## Product Change Notice (PCN)

PCN Number: **PCN-0454905R-01**

Product(s) Affected: **PJ-079BH**

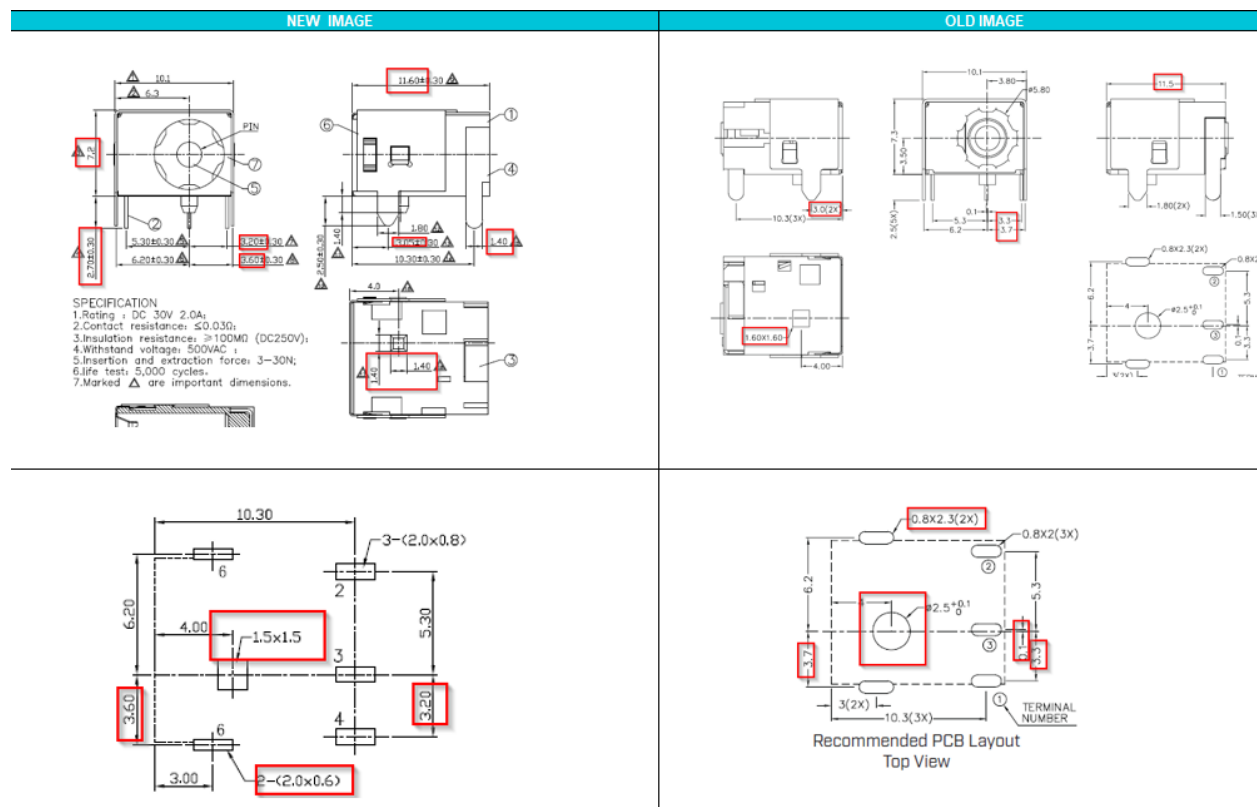
Description of Change: **Minor Housing and footprint differences. Material Change on the housing and terminals. See image Below**

Housing and Terminal Material Changes:

Center Pin: Copper to Brass  
Terminal 2: Copper Alloy to Brass  
Plastic: PA6T or Equivalent to PA9T
